Discussion on increasing the Schnupp asymmetry

A preliminary document exploring allowable ETM's & ITM's mechanical clearances along the beam center line & the feasibility of cookie cutter 'BLANKS' for the following chambers:

WBSC1, LBSC1
(ITMy)

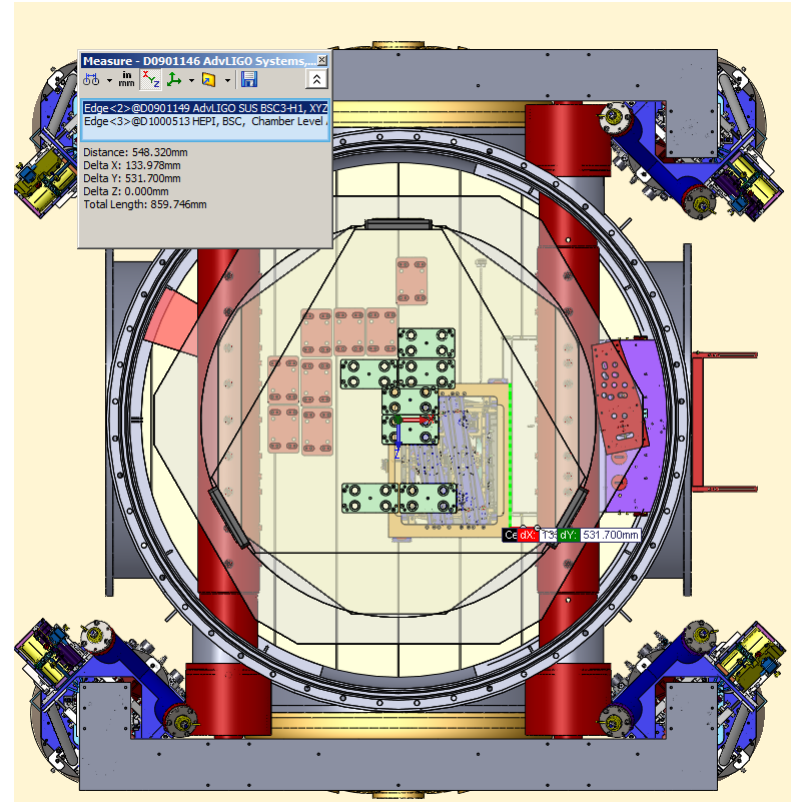
60 mm
Away from Global CS

450 mm
Toward Global CS

450 mm
Toward Global CS

60 mm
Away from Global CS

WBSC3, LBSC3
(ITMx)

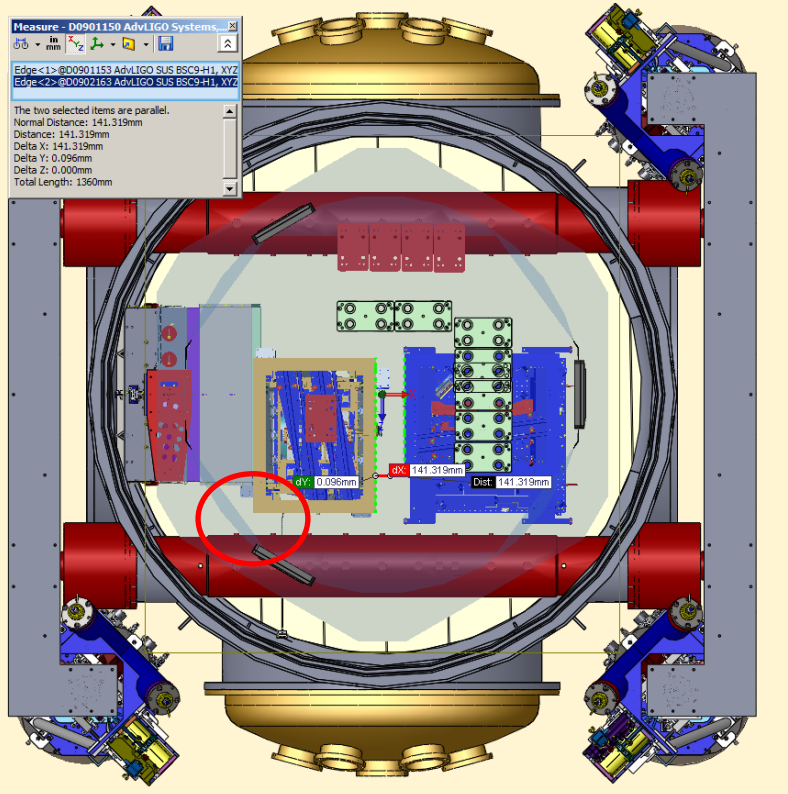
40 mm
Toward Global CS
(Before it hit Stage0 & IF
ACB can be shortened)

WBSC9, LBSC4
(ETM_x)

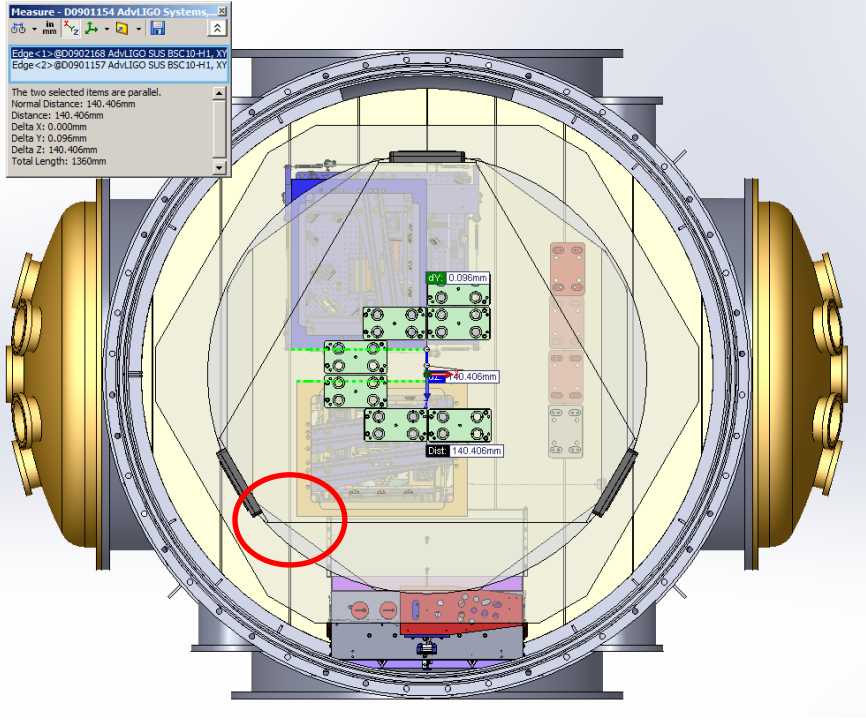
10 mm
Away from Global CS,
(Dog Clamps from ETMX
& TMS could collide)

10 mm
Away from Global CS,
(Dog Clamps from ETMX
& TMS could collide)

WBSC1, LBSC1 (ITMy)

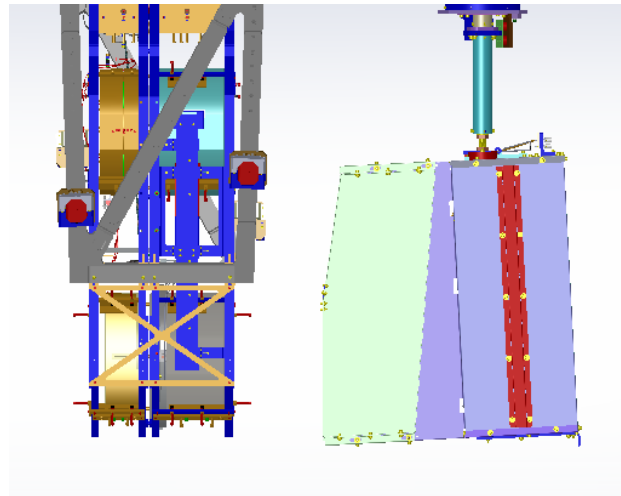
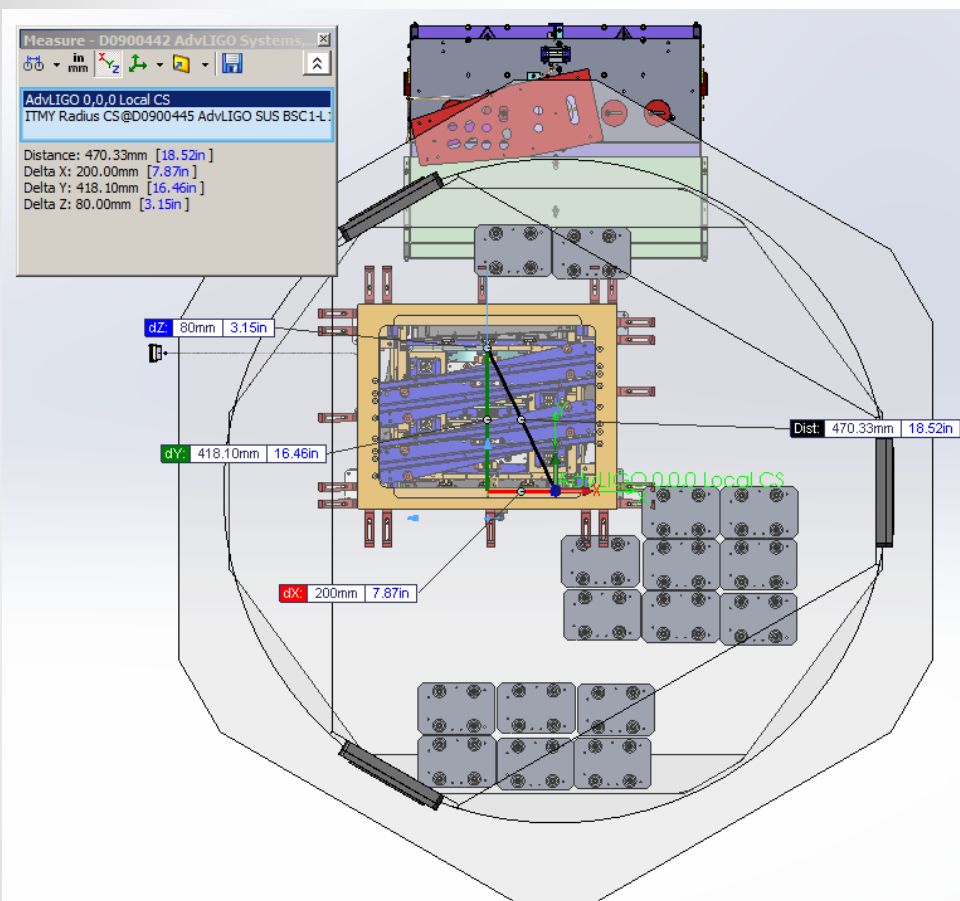
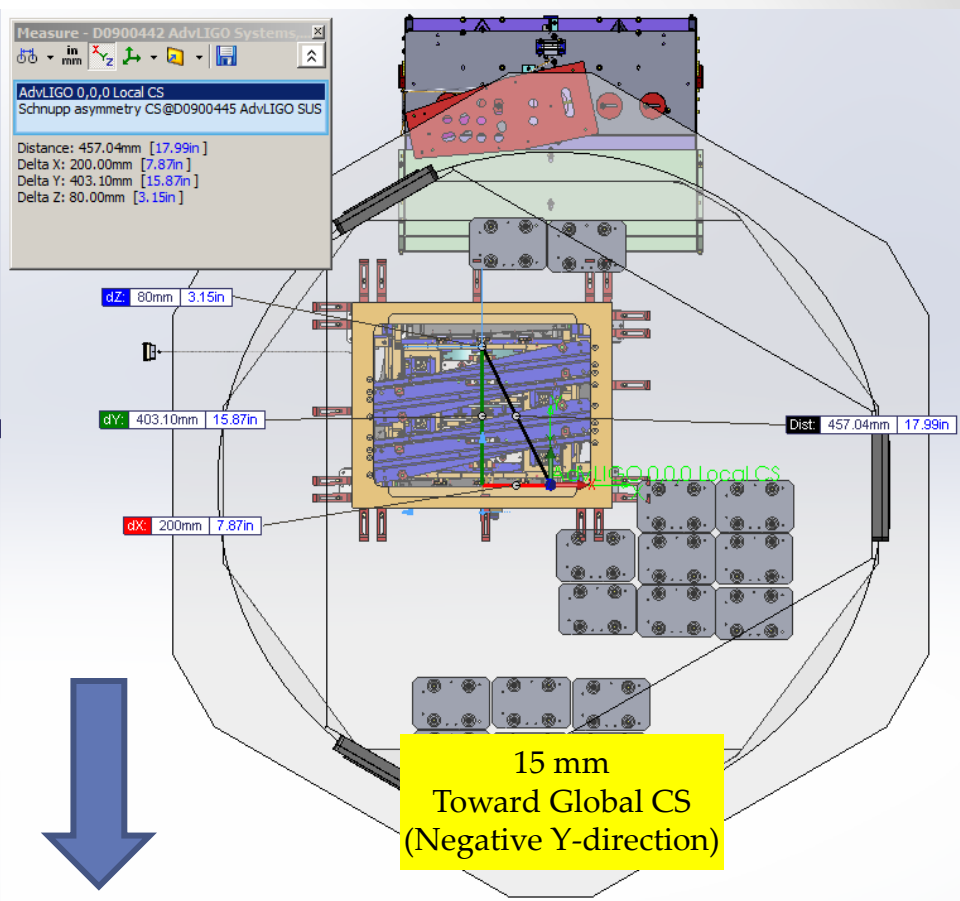
Considerations about increasing the Schnupp Asymmetry on ITMy (WBSC1 & LBSC1) by 15 mm toward the Global CS :

- There is a very insignificant change in the Y-Direction (2 mm) on the overall CG of the table.

- There are no changes on the Dog clamp layout. ITMy will use the same Dog clamps and the same Hole locations.

- The ITMy will be moved 15 mm in the opposite direction of ACB.
(However the ACB may need to be enlarged to get closer to the ITMy.)

- TCS may need to re-align this mirror to work with the new position of the ITMy.

- There are no significant changes to any of these items.

Local Coordinates:
 $X = -200.0 \text{ mm}$
 $Y = 418.10 \text{ mm}$
 $Z = -80.0 \text{ mm}$

Local Coordinates:
 $X = -200.0 \text{ mm}$
 $Y = 403.10 \text{ mm}$
 $Z = -80.0 \text{ mm}$

WBSC3, LBSC3 (ITMx)

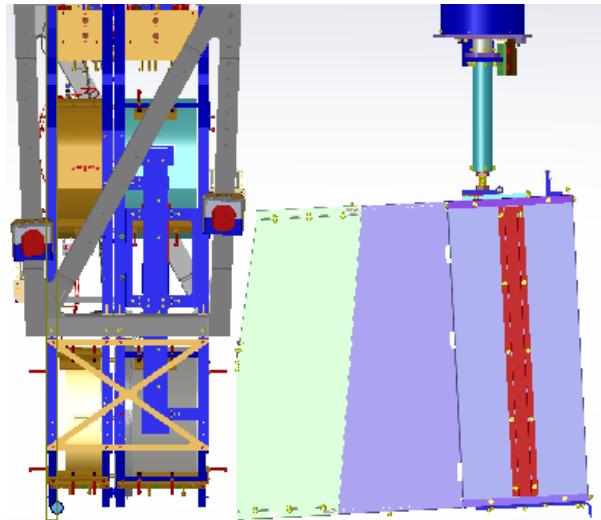
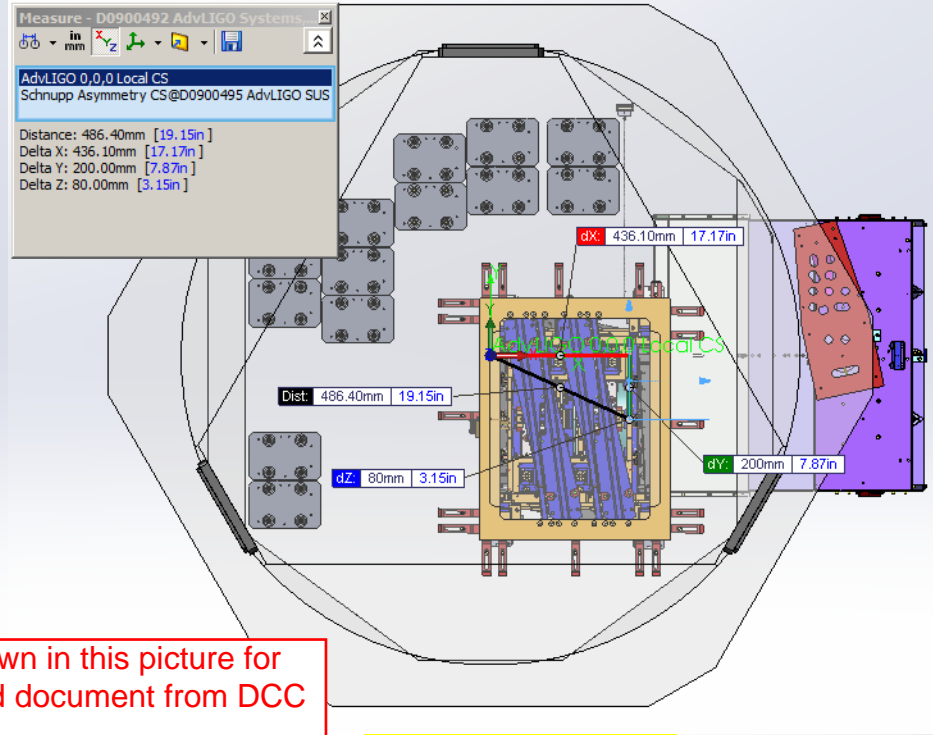
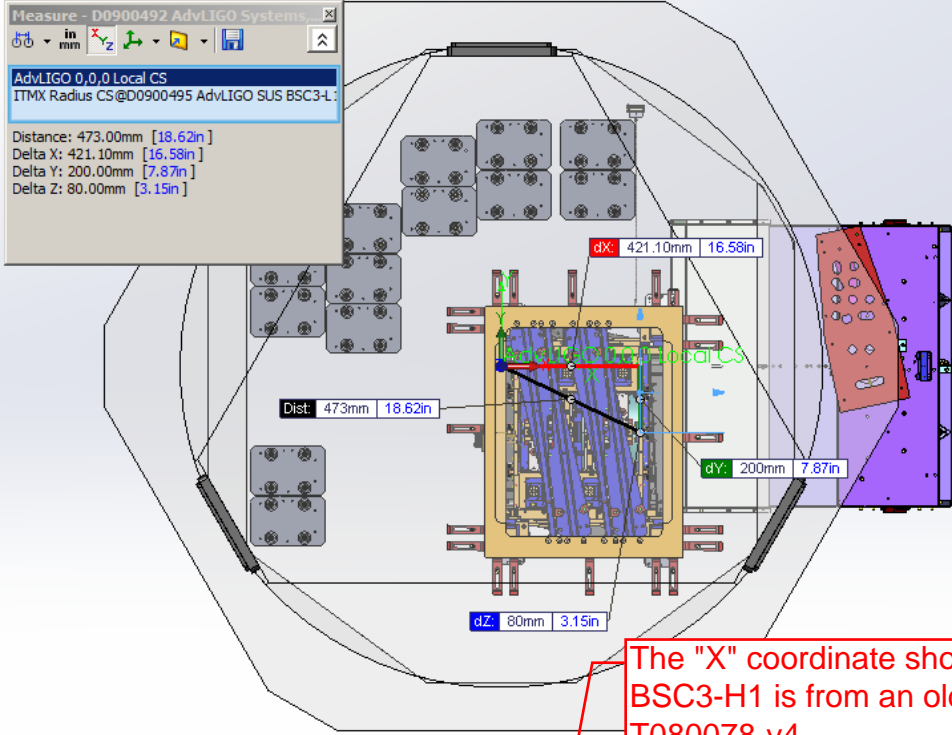
Considerations about increasing the Schnupp Asymmetry on ITMx (WBSC3 & LBSC3) by 15 mm away from the Global CS :

- There is a very insignificant change in the X-Direction (2 mm) on the overall CG of the table.

- There are no changes on the Dog clamp layout. ITMx will use the same Dog clamps and the same Hole locations.

- The ITMy will be moved 15 mm away from Global CS (toward ACB)
(ACB may need to be shortened by 15 mm, to keep same gap with ITMx).

- TCS may need to re-align this mirror to work with the new position of the ITMx.

- There are no significant changes to any of these items.

The "X" coordinate shown in this picture for BSC3-H1 is from an old document from DCC T080078-v4. The actual/correct value for the "X" coordinate should be from document E1101147-v2 and it should be X = 418.0 mm

15 mm
Away from Global CS
(Positive X-Direction)

Local Coordinates:
 $X = 421.0 \text{ mm}$
 $Y = -200.0 \text{ mm}$
 $Z = -80.0 \text{ mm}$

Local Coordinates:
 $X = 436.0 \text{ mm}$
 $Y = -200.0 \text{ mm}$
 $Z = -80.0 \text{ mm}$

WBSC9, LBSC4 (ETM_x)

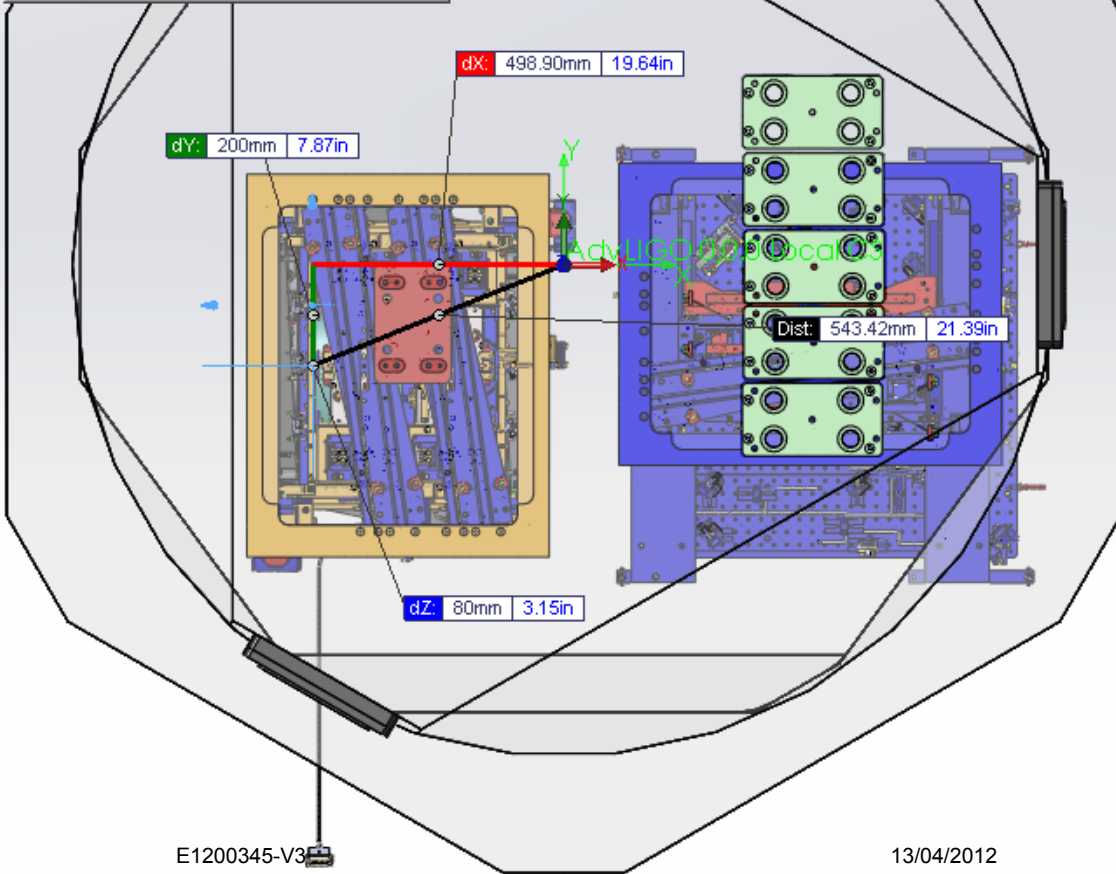
NO CHANGE

Local
Coordinates:
X = -498.9 mm
Y = -200.0 mm
Z = -80.0 mm

WBSC10, LBSC5 (ETMy)

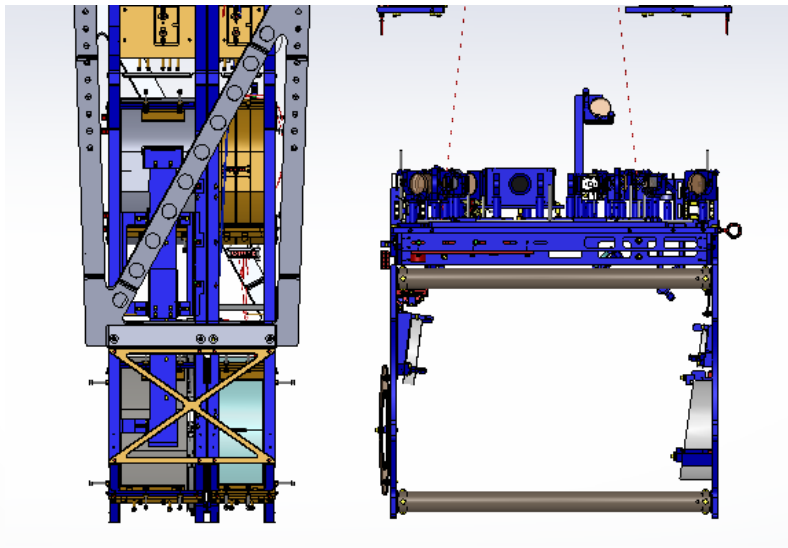
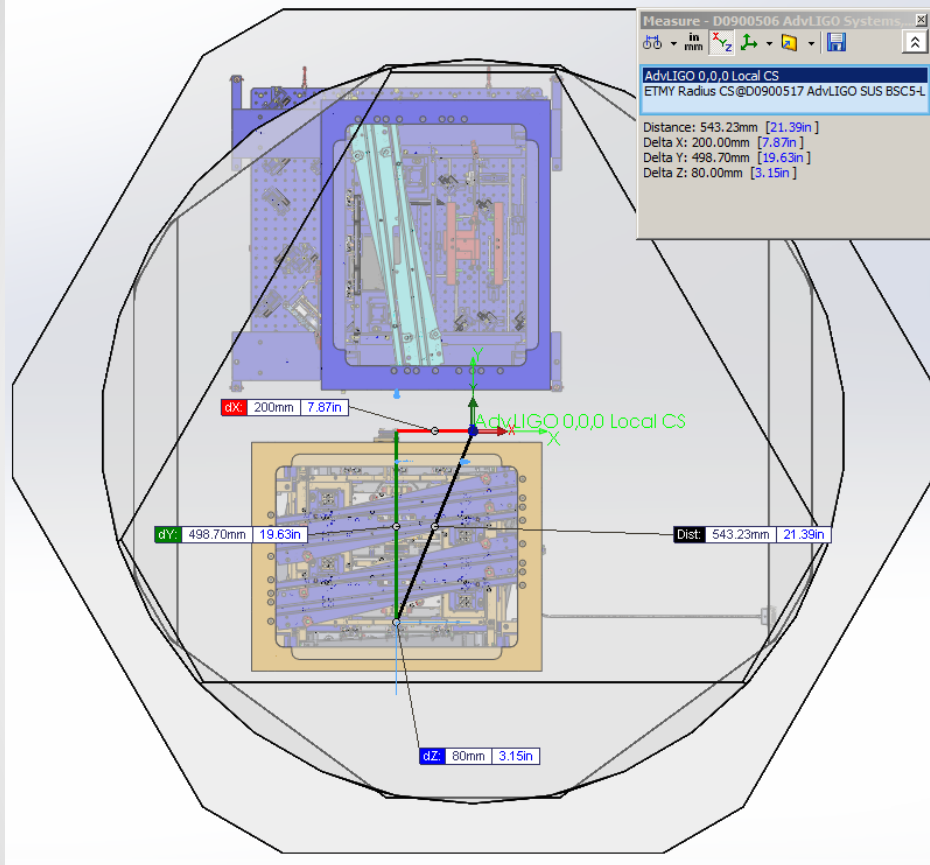
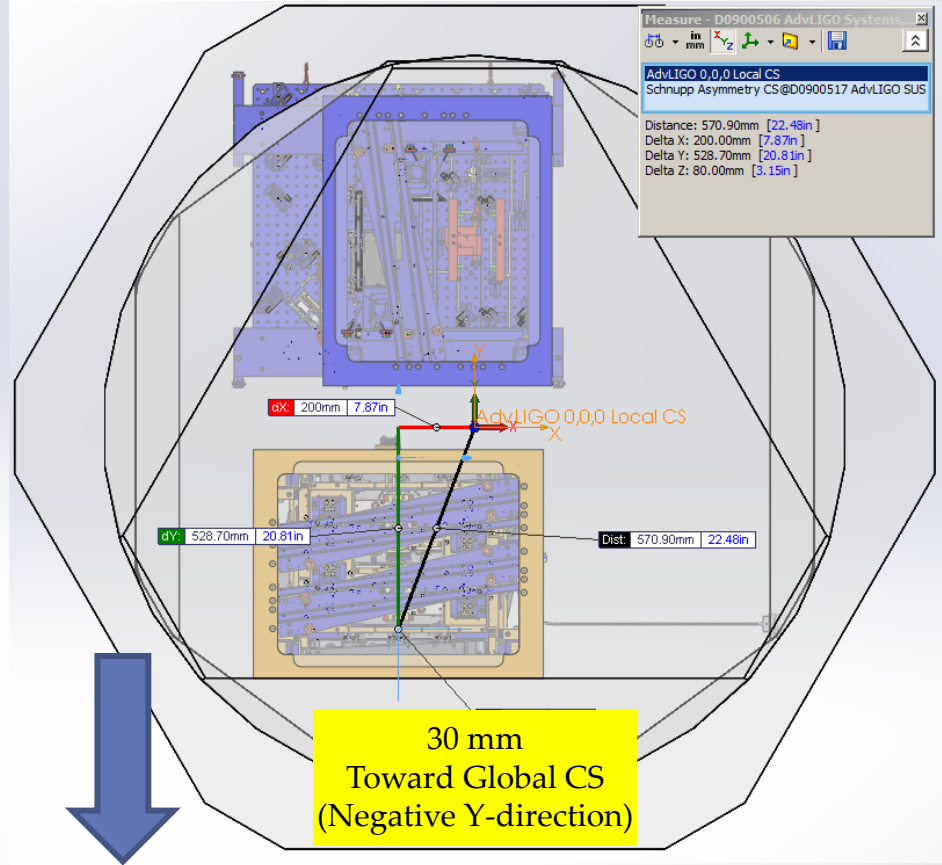
Considerations about increasing the Schnupp Asymmetry on ETMy (WBSC10 & LBSC5) by 30 mm toward the Global CS :

- There is a very insignificant change in the Y-Direction (4 mm) on the overall CG of the table.

- There will be minor changes on the Dog clamp layout. ETMy will use the same Dog clamps but they will use some other available Hole locations for clamping.

- The ETMy will be moved 30 mm toward the Global CS (away from TMS). TMS may need to be moved to keep same gap with ETMy

- There are no significant changes to any of these items.

Local Coordinates:
 $X = -200.0 \text{ mm}$
 $Y = -498.70 \text{ mm}$
 $Z = -80.0 \text{ mm}$

Local Coordinates:
 $X = -200.0 \text{ mm}$
 $Y = -528.70 \text{ mm}$
 $Z = -80.0 \text{ mm}$
